TITLE: **CHANGE OF ZONE NO. 11042, Lincoln Public Schools District Office Planned Unit Development,** requested by Lancaster County School District #1, on property generally located at the southwest corner of Lyncrest Drive and O Street.

LINCOLN CITY/LANCASTER COUNTY PLANNING STAFF REPORT

PROJECT #: Change of Zone #11042 - Lincoln Public Schools District Office Planned Unit Development (PUD)

SITE PLAN

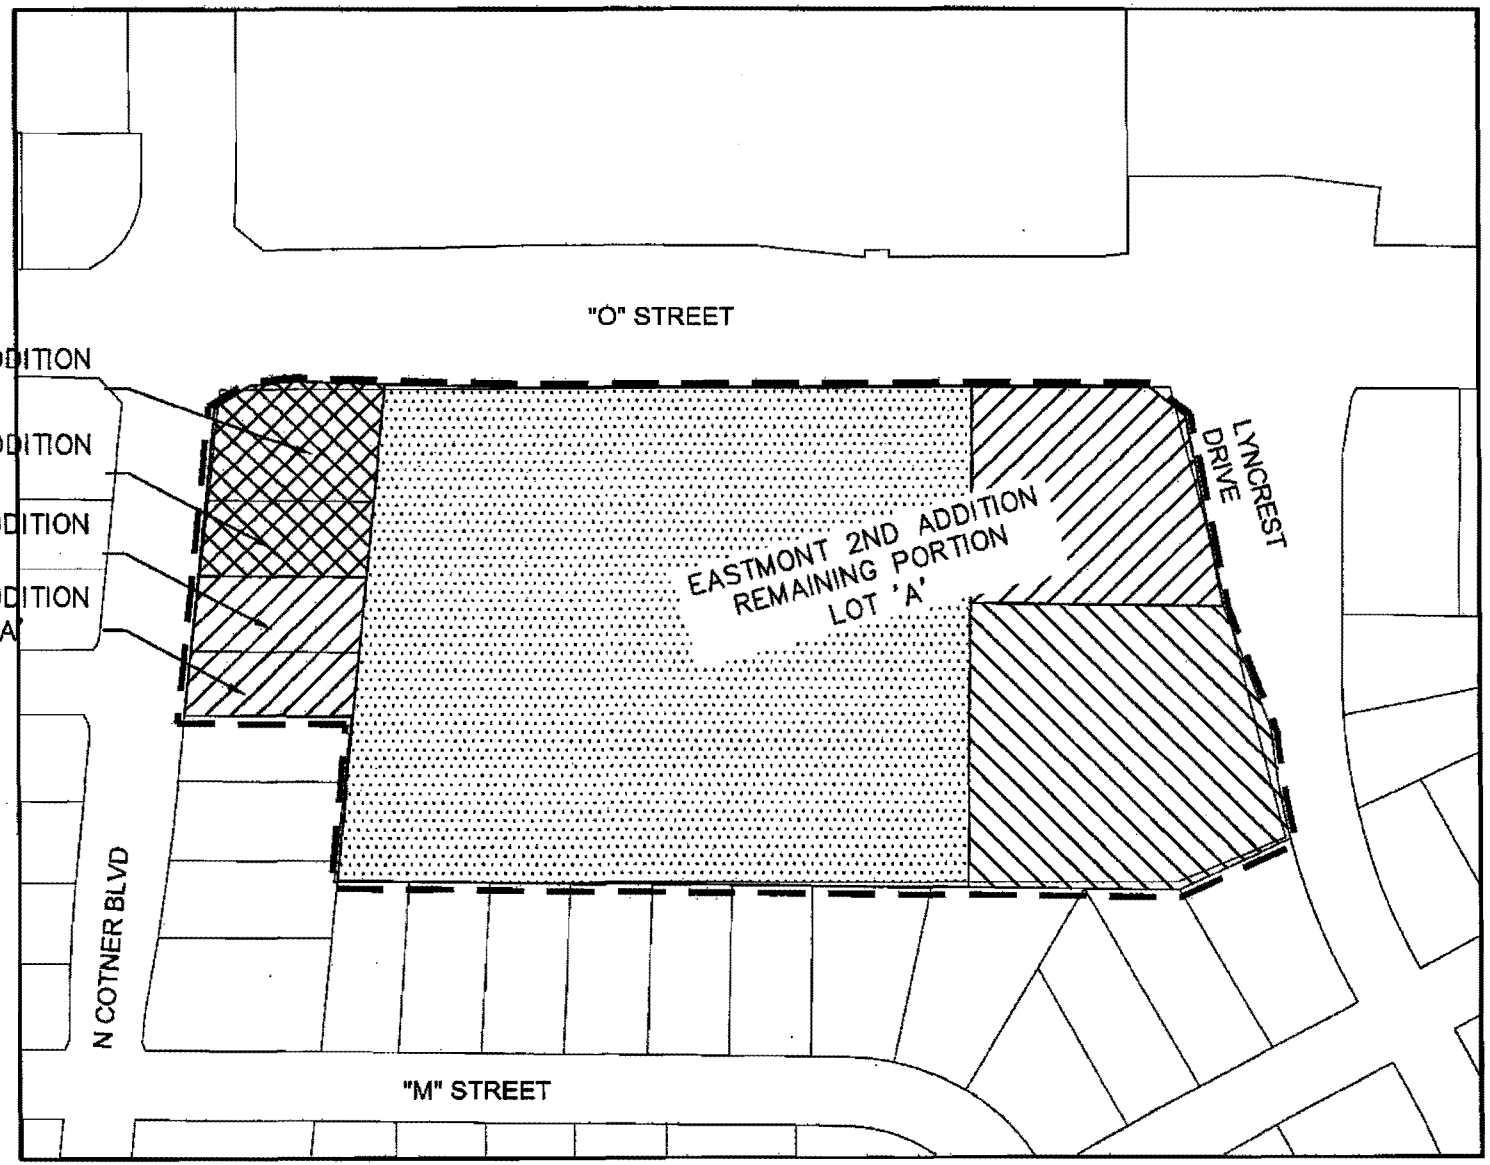
1.1.3 Show a 10 foot rear setback dedicated to open space and required screening.

1.1.4 Revise the front setback adjacent to Lyncrest Drive showing that the setback is 20 feet except in the area where it is adjusted due to the irregular shape of the lot and where a portion of the corner of the lot was previously dedicated as right-of-way.

1.1.5 Delete the waivers from Sheet 1 of 1 as they are contained within the associated development plan.

1.1.6 Revise Waiver Note #3 to state: "SETBACKS ARE ADJUSTED PER THE BUILDING ENVELOPE SHOWN ON THE SITE PLAN. THE PLANNING DIRECTOR CAN MAKE MINOR ADJUSTMENT TO THE FRONT AND SIDE SETBACKS BY ADMINISTRATIVE AMENDMENT. ADDITIONALLY, IF A BUILDING OVER 40 FEET IN HEIGHT IS WITHIN 65 FEET OF THE SOUTH PROPERTY LINE, THEN THE SETBACK TO THE SOUTH LOT LINE WILL EQUAL THE HEIGHT OF THE BUILDING." Then, clearly delineate and label the building envelope on the site plan. Given the drawing is drawn to scale, the setback can be dimensioned if necessary. **(**Per Planning Commission, at the request of the applicant and agreed upon by staff, 02/22/12**)**

1.1.7 Revise the prohibition note as follows:
